Item #7:
Village President Rodriguez
B. IL Route 22 – West Of IL Route 83 - Update

Illinois Route 22
Quentin Road to IL Route 83
P-91-284-00

**Recommended Improvement Plan – Final Modifications
Presentation to Village of Long Grove Board**

Date: 06/16/2010
Exhibit D-5

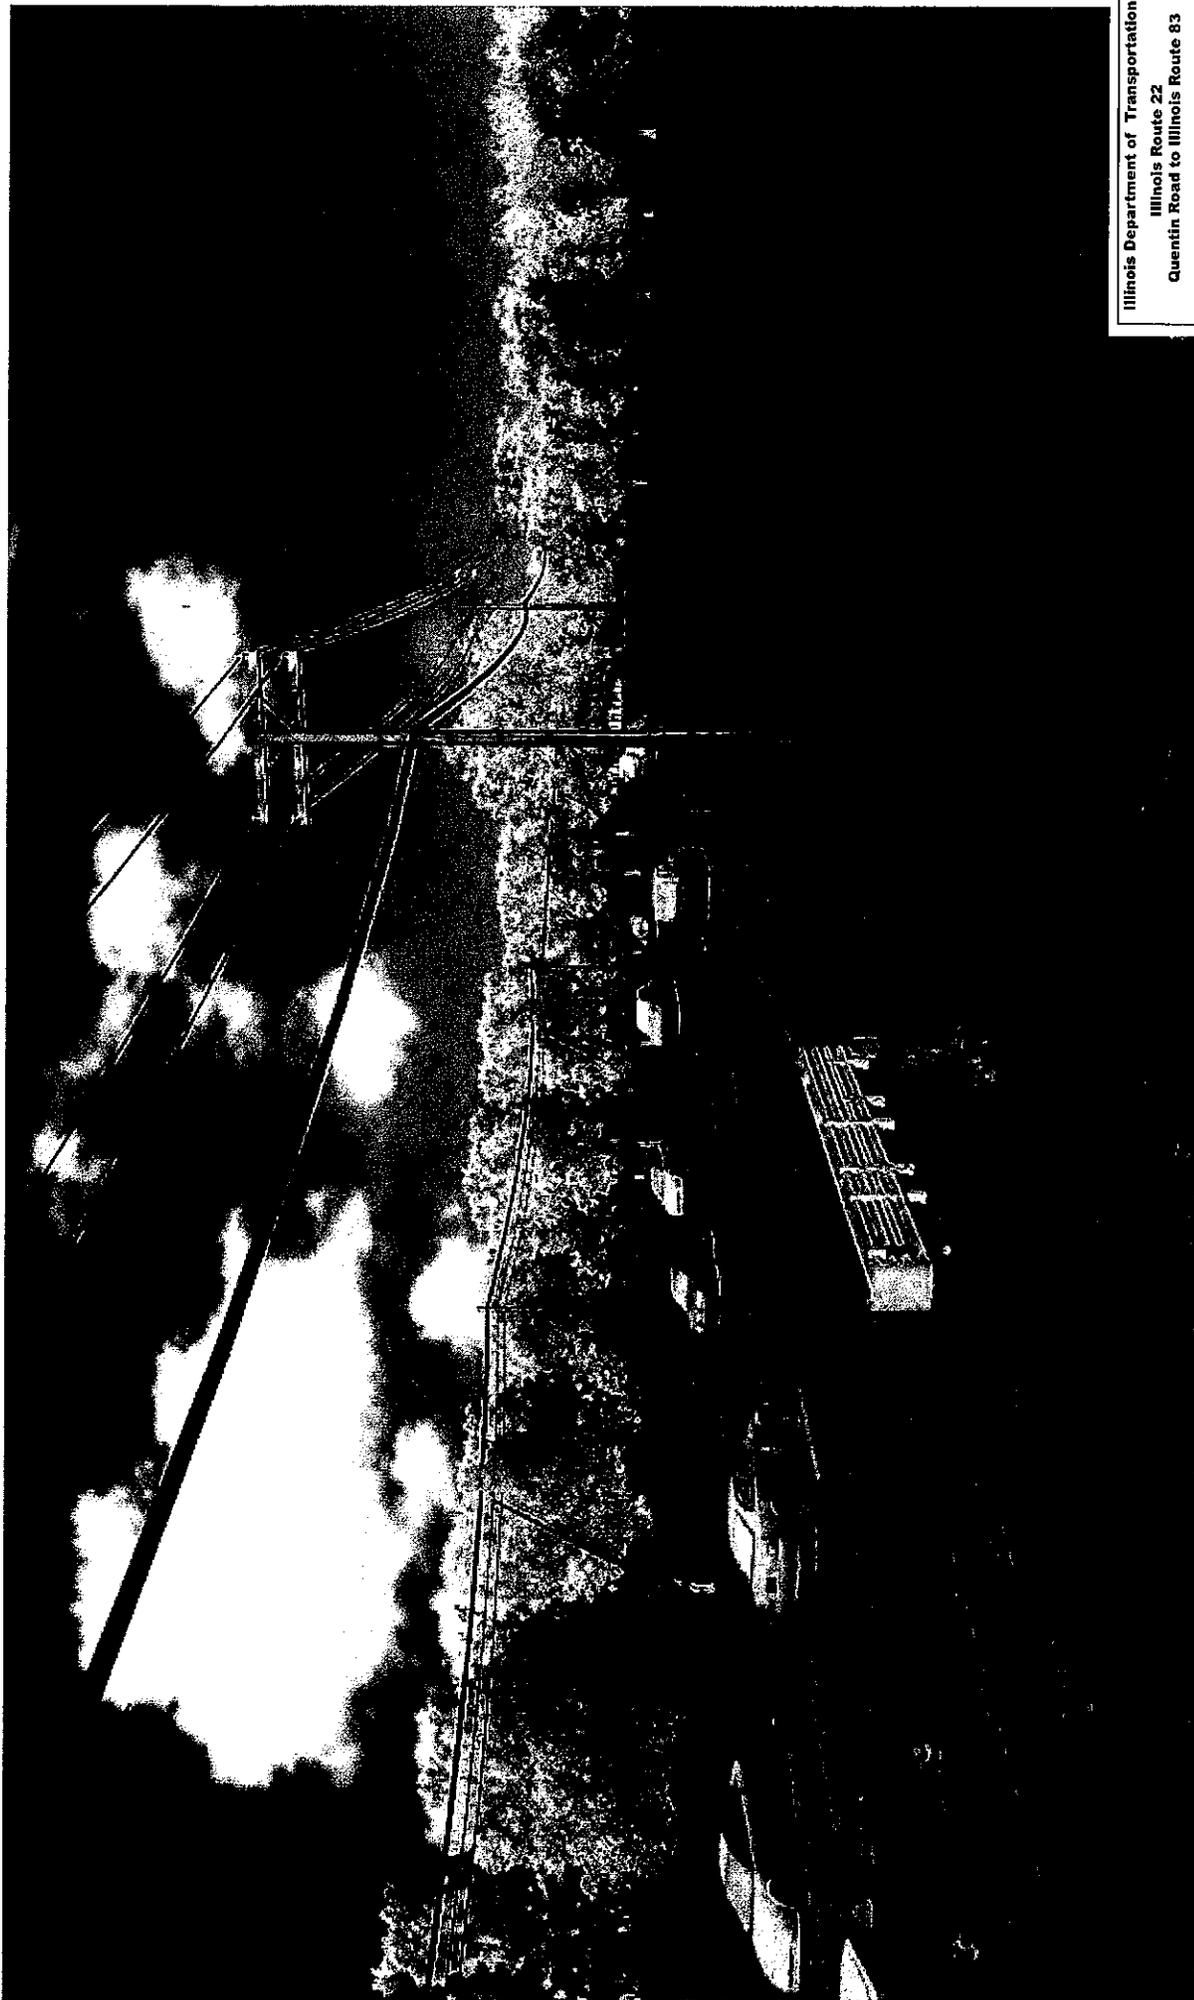
- Exhibits D-5 through D-8 show the same area as viewed from a point on Oak Creek Lane. The back of the concrete barrier wall is shown. Below is the actual retaining wall. A decorative concrete form liner could be used on this back face of the retaining wall.
